SUBJECT: ADDITIONAL INFORMATION IN SUPPORT OF WESTINGHOUSE RESPONSE TO
RAI 952.44 - 952.46

Question 952.44

Attachment to Westinghouse Letter NTD-NRC-94-4114
Additional Information in Support of Westinghouse Response to RAI 952.44 - 952.46

Figure 2 Pressurizer pressure (psia) vs. Time

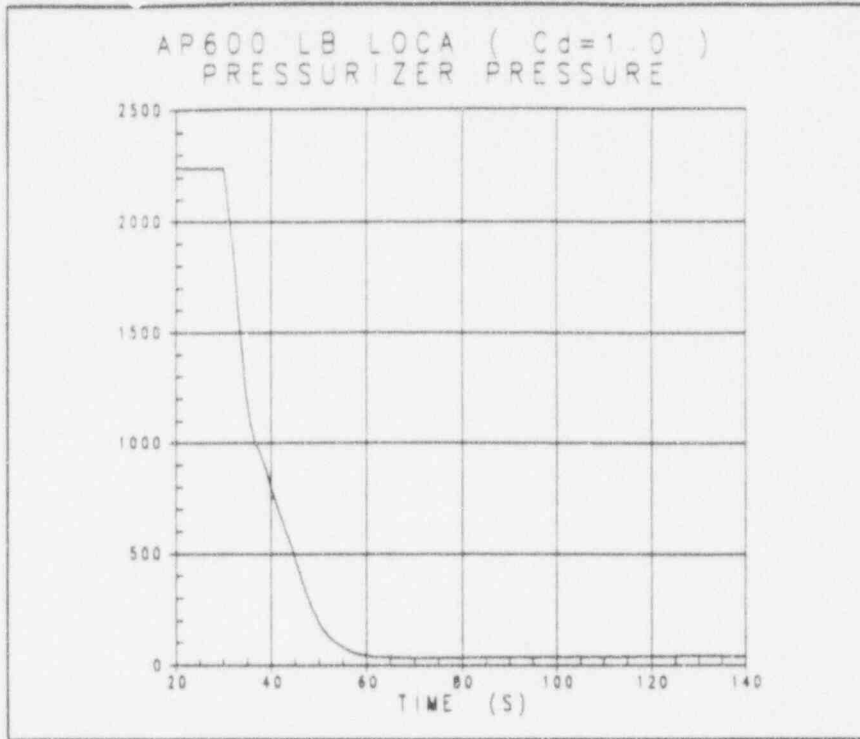
- a. pressurizer pressure and mass flows
- b. upper-plenum pressure
- c. break mass flows, integrated break mass flows, and exit void fractions for both vessel-side and pump-side break locations

- Figure 2 Pressurizer pressure (psia) vs. Time
- Figure 3 Pressurizer mass flow (lbm/sec) vs. Time

The plot location is the bottom cell of pressurizer PIPE component 16.

Figure 49 Reactor Power (MWth) vs. Time

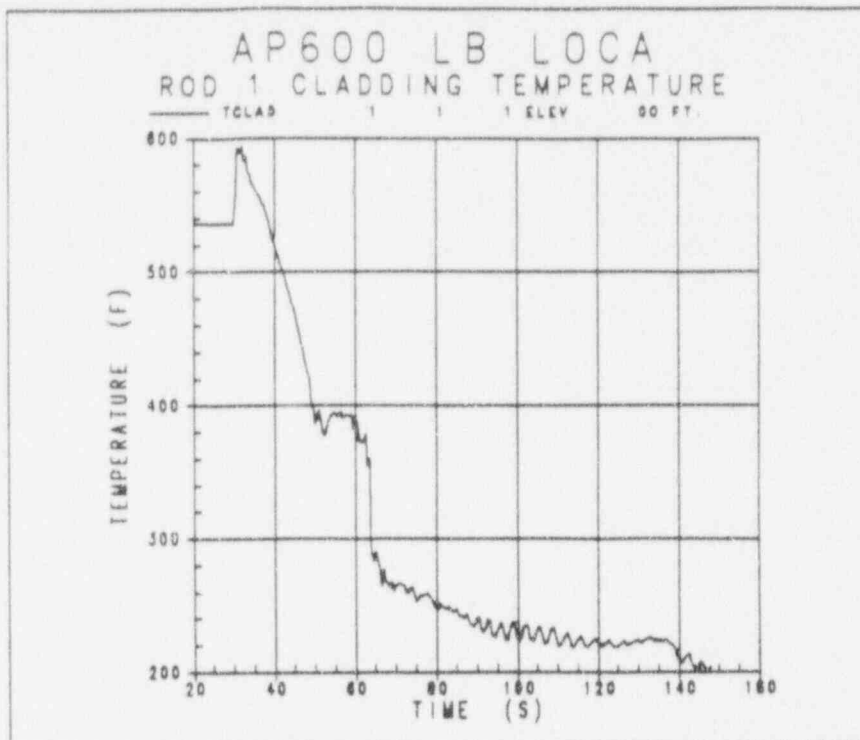
- j. pump speeds, mass flows, and void fractions
- k. reactor power
- l. core inlet boron concentration
- m. fuel clad temperatures at selected core elevations for all modelled fuel rods (average and hot rods)

Figure 49 Reactor Power (MWth) vs. Time

Figure 102 Steam generator secondary side liquid temperatures (deg. F) vs. Time

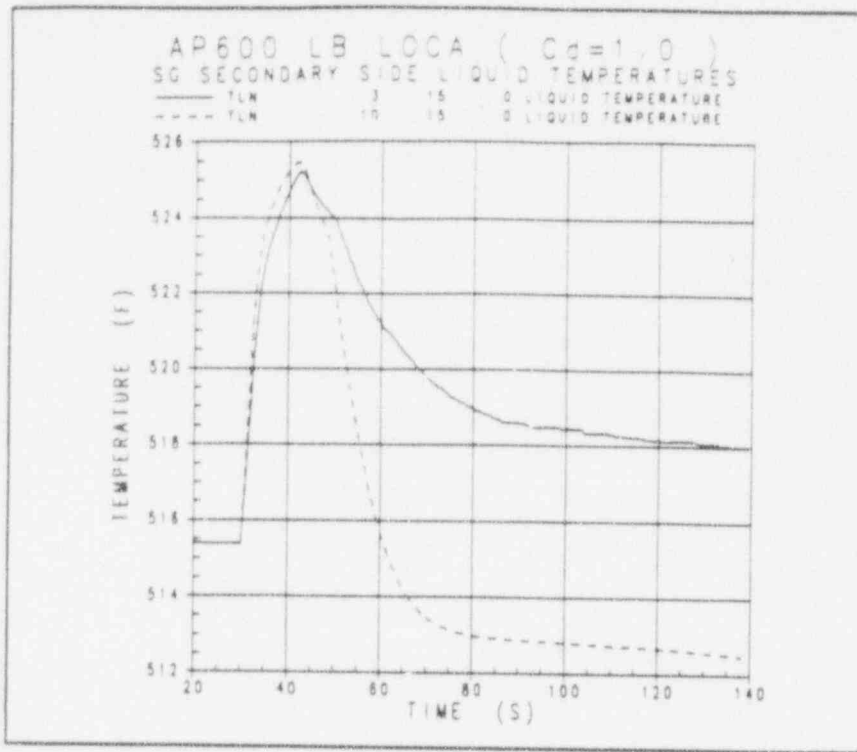
- p. steam generator feedwater flow and steam flow
- q. steam generator secondary-side pressure
- r. steam generator secondary-side liquid level and temperatures, and

Figure 102 Steam generator secondary side liquid temperatures (deg. F) vs. Time

Steam generator secondary side parameters are provided for the top cell of the secondary side of STGEN components 3 and 10. Steam generator secondary side liquid levels are not available.
